## Field Safety Notice

*Preventive Corrective Action*  
concerning  
*Adapter for extension device 1150.59AC*

Figure 1: Adapter for extension device 1150.59AC

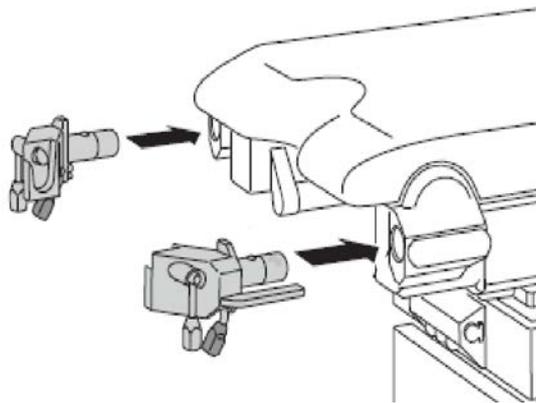
Within the framework of our market surveillance, we have been made aware of complaints in which handling problems have occurred with both adapters for the extension device.

The root cause analysis has shown that the latch designed for safe lock of the seat plate (support frame) was incorrectly mounted on affected adapters. This makes handling difficult

when mounting and removing the support frame. The latches are designed to prevent the levering of the support frame upwards in the event of a collision (e.g. with the column head of the OR table column). Due to the incorrect mounting we cannot guarantee that the latches fulfil this function.

Figure 3: Correctly mounted latch

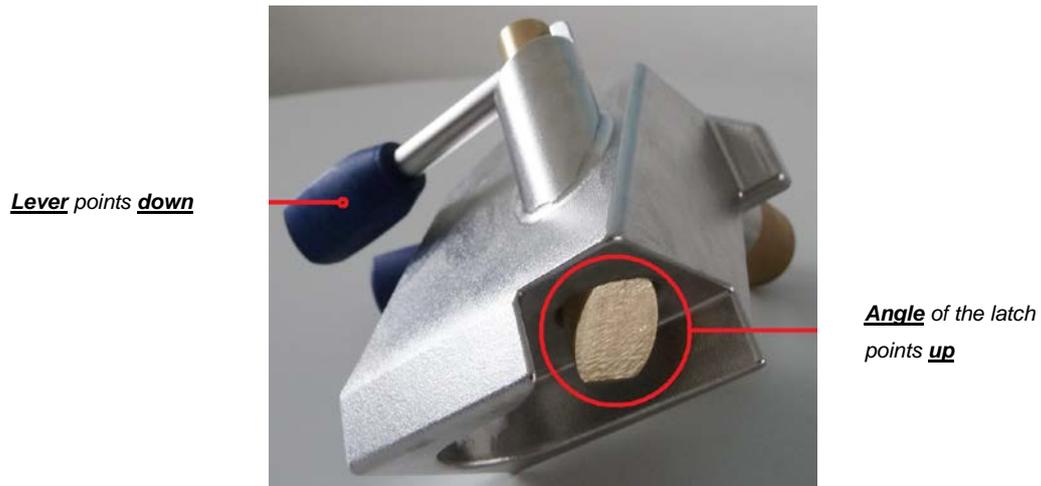
The latch is incorrectly mounted when the angle of the latch points down when the lever is pointing down.

Figure 2: **Incorrectly** mounted latch

When the angle of the latch points upwards with the lever in the same position, then the latch is mounted correctly:

Please check according to the characteristics described above whether the latches of your adapters were mounted correctly.

If you are in possession of faulty adapters, please contact MAQUET service immediately in order to arrange a free replacement of the adapters.
